SECTION 3.0: Environmental Analysis

Letter - C35
Page 11

SECTION 3.1: Hydrology and Water Quality

FIGURE C3.0-1

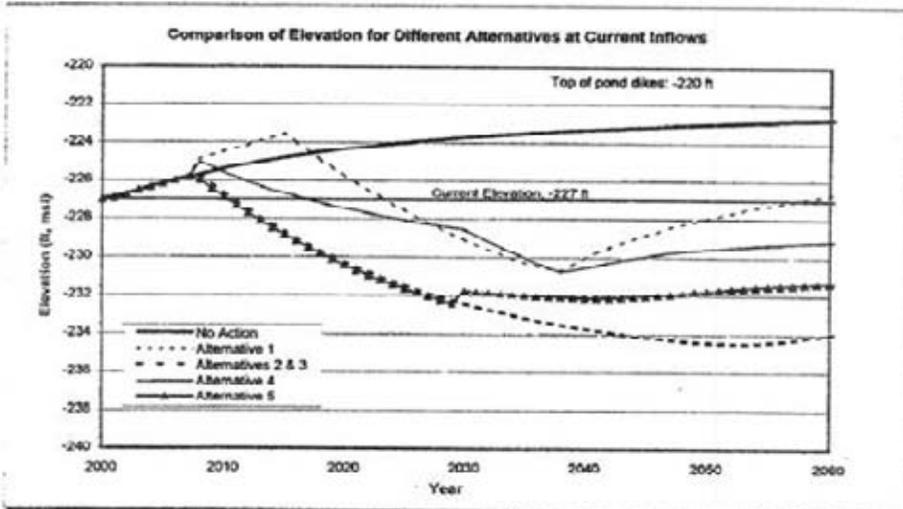
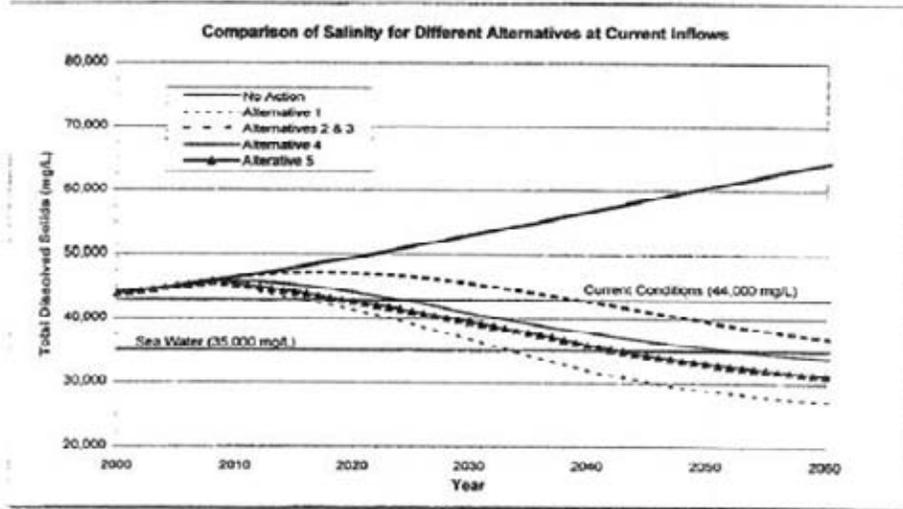
the Baseline must represent the expected variability of environmental resources that could reasonably be expected in the future, based on the present and historical state of such resources. ... The IIDSS model was developed by IID "to predict annual water conservation volumes ... and simulate the resulting changes in the quality and quantity of drainage water that flows in IID's drains and rivers." (page 3.1-93 this Draft EIR/EIS) It does not provide a Baseline for the Salton Sea predicted conditions, but only input for another model, the Salton Sea Accounting Model (SSAM) developed by Reclamation (Weghorst 2001). Thus the Project Baseline predictive modeling graphs of Salton Sea surface elevation, surface area and salinity shown in Figure 3.0-1 are the result of serial modeling. The SSAM model is believed to be similar to that used by SSRP in their Draft EIR/EIS. This model, developed by Thiery (1998) and significantly enhanced for use by SSRP (Reclamation 1999), has also been used to provide predictive graphing of Salton Sea surface elevation, surface area and salinity. These are shown in Table C3.0-1: Summary of Modeling Results and Assumptions, Figure C3.0-1: Projected Changes in Salinity and Elevation Over Time at Current Inflows (1.36 MAFY), and Figure C3.0-2: Projected Changes in Salinity and Elevation Over Time with Inflow Reduced to 1.06 maf/yr (Source: www.lc.usbr.gov: Salton Sea Restoration Draft EIS/EIR). As shown in Table C3.0-2: Comparison of IIDSS/SSAM and SSRP Model Results for 2060, the results provided by these two models differ. Both models have inflows to the Salton Sea as the primary driver. The SSRP modeling clearly states the inflow assumptions. For the IIDSS/SSAM, the reader is left to derive the inflows based on data scattered throughout the Draft EIR/EIS. Table C3.0-3 provides an accounting of the IIDSS/SSAM input Salton Sea inflows. Looking at the data, it is apparent that 1.36 MAFY No Project predictions represent the Existing Condition referred to in the Draft EIR/EIS (Water Transfer). Unfortunately, there is no directly comparable data set for Baseline, as defined in this Draft EIR/EIS (water transfer). Table C3.0-3 set the Baseline model inflow at 1285 KAFY. This represents 75 KAFY less water inflow than the No Project flow used by the SSRP model, the difference of which is significant enough, that we cannot directly compare the designated Project Baseline model predictions with the SSRP No Project model predictions. However, looking at the SSRP No Project predictions relative to the Alternative 4 IIDSS/SSAM model prediction, the inflows are substantially the same, yet there are significant differences in the model results with the IIDSS/SSAM indicating a greater mean sea level and acreage loss, and a greater increase in salinity. This leads to the conclusion that the Baseline model predictions may be overstating the decline of Salton Sea. If one believes the SSRP model results, and extrapolates data shown in Tables C3.0-2 and Table C3.0-3, the conclusion can easily be reached that the Baseline should reflect no net loss to Salton Sea surface elevation. Before the Baseline utilized in the Draft EIR/EIS can be accepted, the differences between the two model results must be reconciled.

- Statement: "Once Baseline conditions are established, impacts can be assessed by comparing Project impacts to the Baseline condition. Therefore, the Baseline ... represents the existing conditions at the time the NOP was published, based on historical data and reasonable, anticipated future changes in these conditions over the Project term. By including a future projection of existing conditions in the Baseline, effects caused by the Project can be differentiated from effects that are reasonably expected to result from existing conditions and trends. ..." This is true only if the impacts of the SSRP are ignored. Figure 3.0-1 and Figure C3.0-2 clearly show that Salton Sea surface elevation levels can be maintained and salinity reduced. As stated previously, the Proposed Project and Alternatives MUST be evaluated relative to the Baseline, but also relative to the SSRP program.

Please refer to the Master Response on *Biology—Approach to the Salton Sea Habitat Conservation Strategy* in Section 3 of this Final EIR/EIS.
